Subject: **FCC Class II Permission Change Request for FCC ID: 2AL8S-0235C7PH**

This is to request a Class II Permission Change Request for FCC ID: 2AL8S-0235C7PH, originally granted on 03/17/2024.

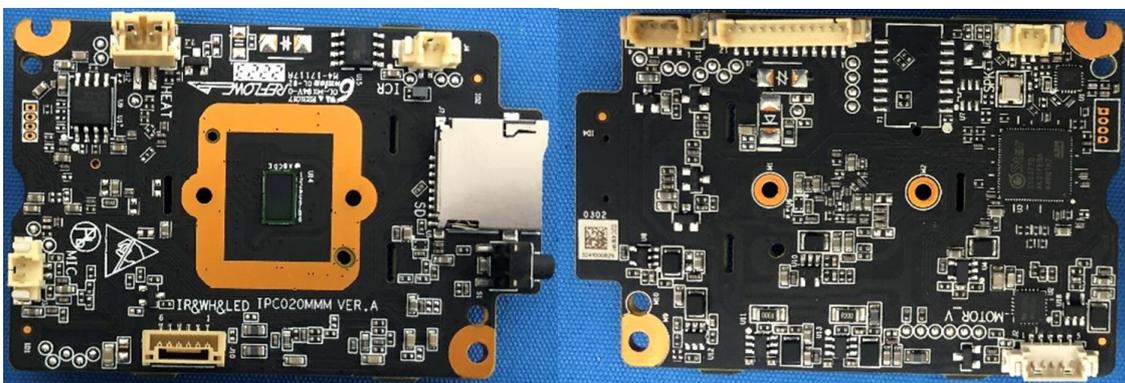
The Major change filed under this application is added model numbers and changed the main board of non-transmitter portions in order to improve the resolution from 3MP to 5MP, which does not affect RF function and performance, please refer to below photos for more details:

Original:

New:

Considering the differences, only “Conducted Emissions at AC Power Line (150kHz-30MHz), Radiated Emissions which fall in the restricted bands, Radiated Spurious Emissions Below 1GHz

and Radiated Spurious Emissions Above 1GHz” were retested, other test data please refer to original report.
